TECHNICAL INFORMATION

- Subject** ▶ Change on Gear Housing
- For Models** ▶ 4100NB,4100NC(Cutters) and 4200N(Circular saw)
- Description** ▶ Changed to the gear housing which has been used for 4100NH as illustrated below.

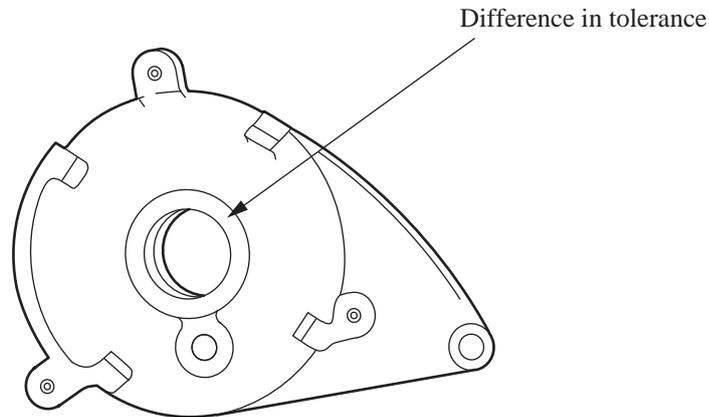
The only difference between the current and the new is the difference in tolerance of the bearing chamber and the groove for O Ring.
And so no problem on interchangeability for repairing.
